CASTLEROCK (EAST ELLIOTT) WATER, SEWER, AND RECYCLED WATER STUDY

Prepared For:
Padre Dam Municipal Water District

SUBJECT: CASTLEROCK WATER, SEWER, & RECYCLED WATER STUDY – Response to Comments

Figure 4-1

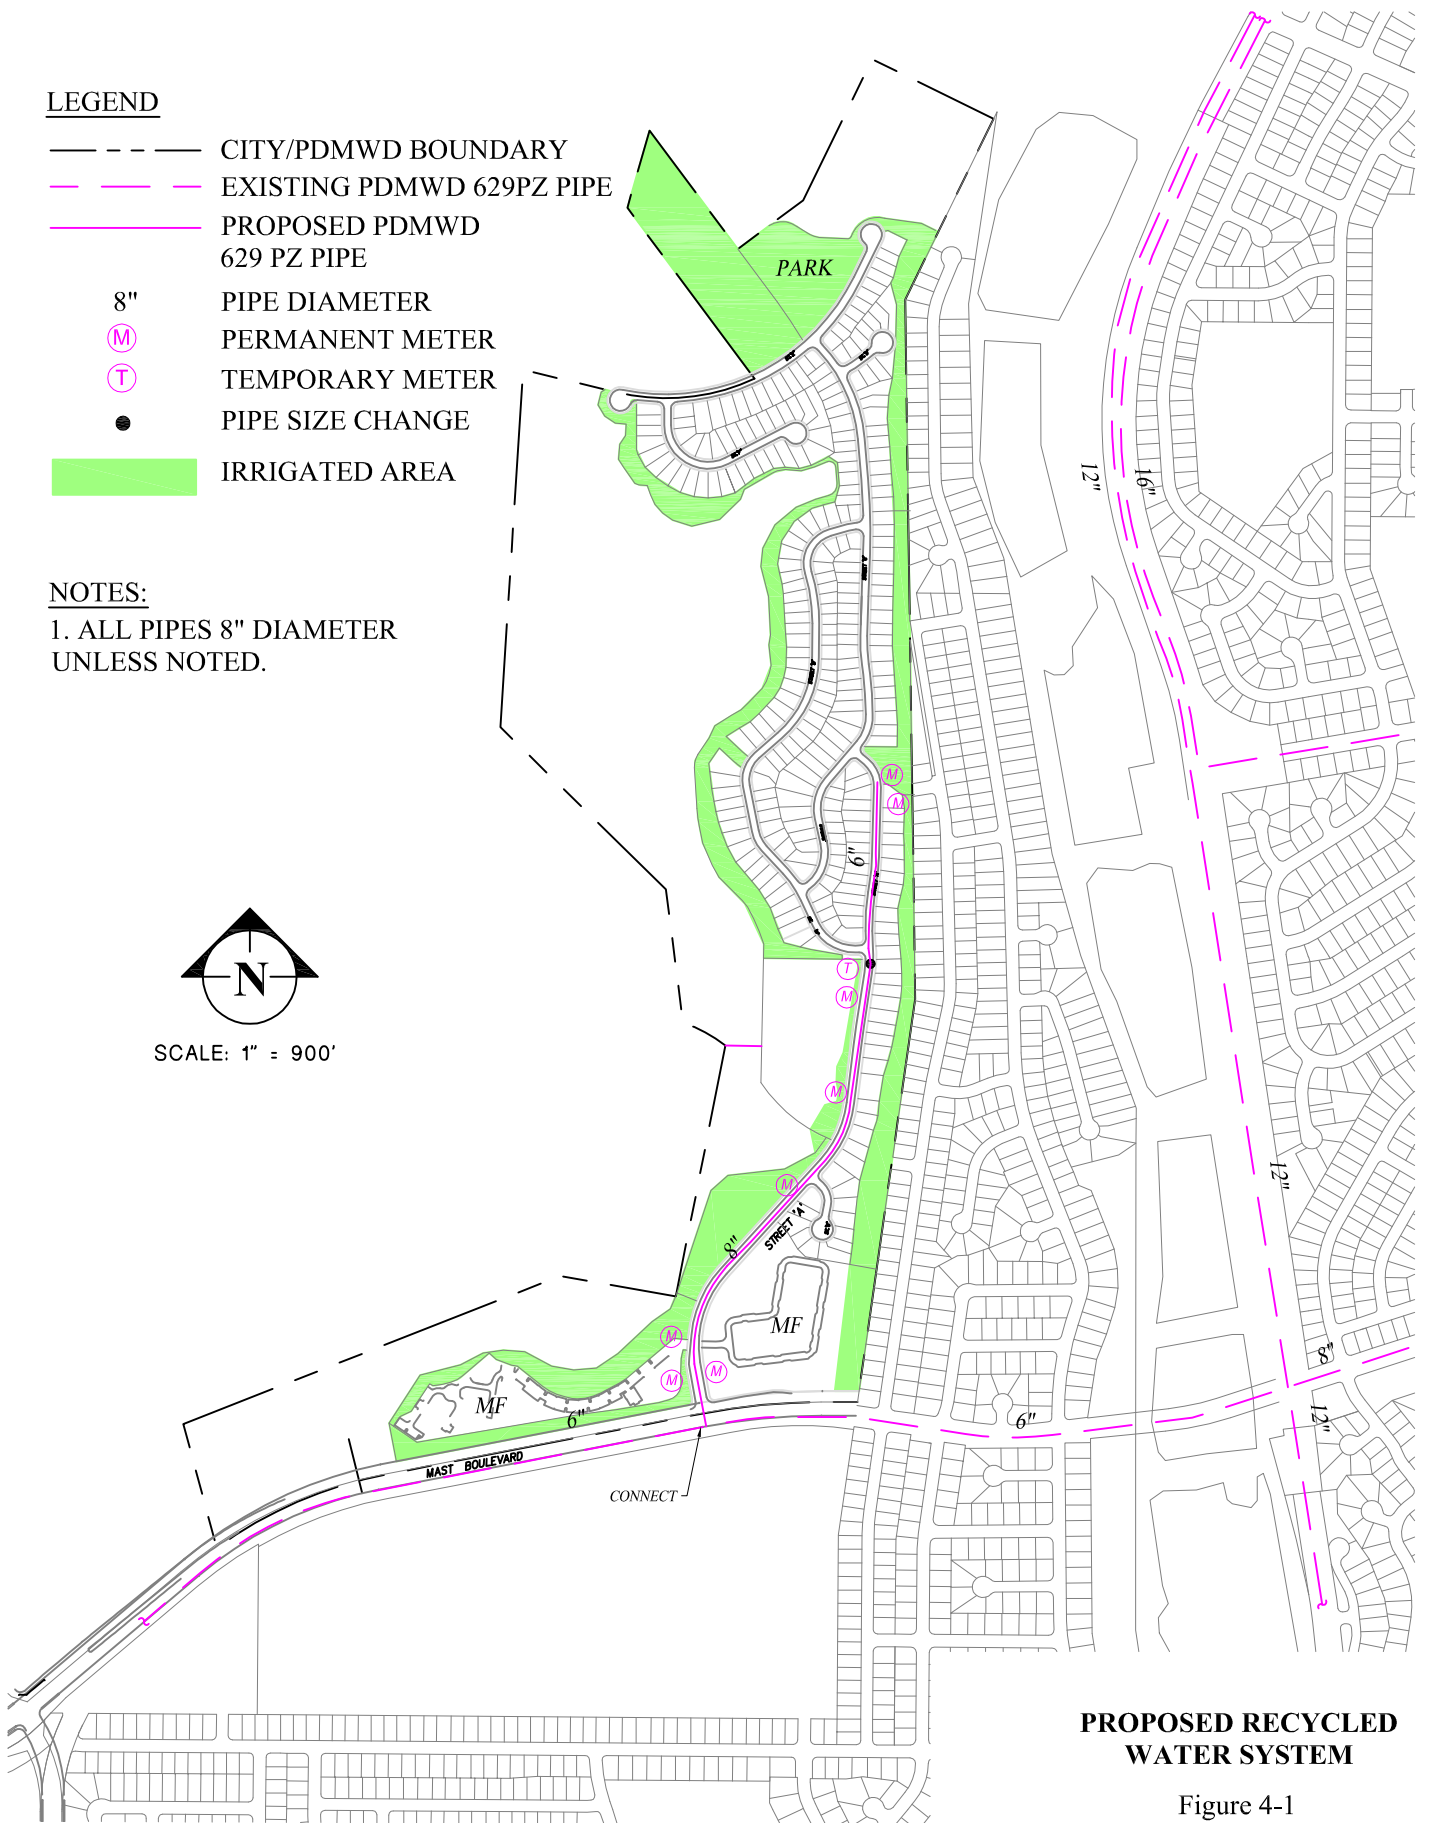
4. Label Street A on figure 4-1.

5. Revise figure 1 to include irrigation areas and park locations.

Revised per comment.

Proposed irrigated areas are shown on Figure 4-1.
